Product Change Notification

We previously announced that we would change the specification for the EF2-D30,60 in October, 2020. (PCN2020-15)
However, we will change the shape of the housing and end plate.
In addition, we will add two target products.

■Product List PCN2020-24-1_【Revised&Reissued】EF2-D30, D60 Product specification change

■ Changes PCN2020-24-1_【Revised&Reissued】EF2-D30, D60 Product specification change

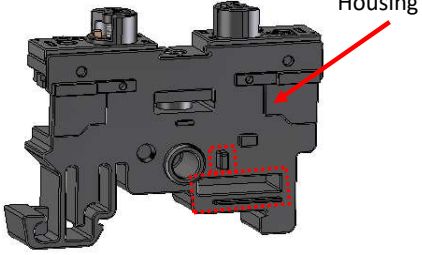
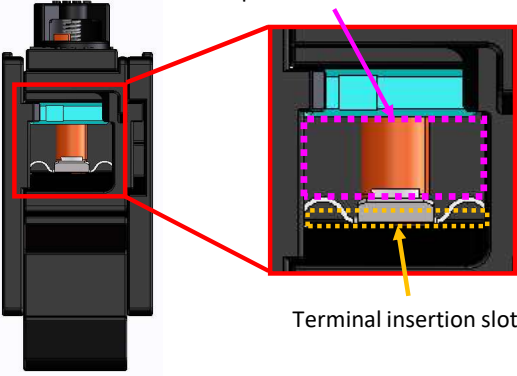
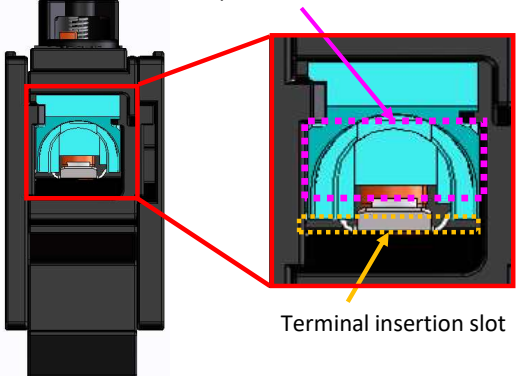
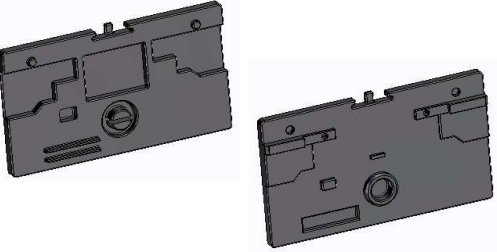
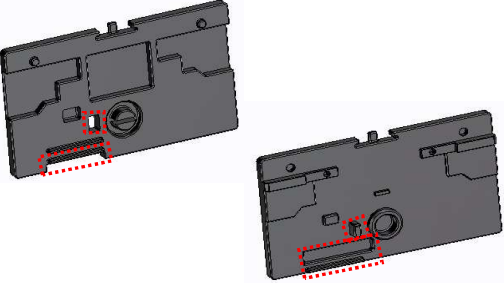
【Current product】	【Replacement product】
Housing

Lock plate

<p data-bbox="363 1088 724 1115">There is space for terminal to enter</p>  <p data-bbox="507 1417 738 1444">Terminal insertion slot</p>	<p data-bbox="906 1088 1299 1115">There is no space for terminal to enter.</p>  <p data-bbox="1098 1417 1329 1444">Terminal insertion slot</p>
End plate * Only for EF2-D30-1, EF2-D60-1

<p data-bbox="196 2007 411 2040">  ...Changes </p> <p data-bbox="204 2051 858 2085">These changes will not affect the performances of the product.</p>
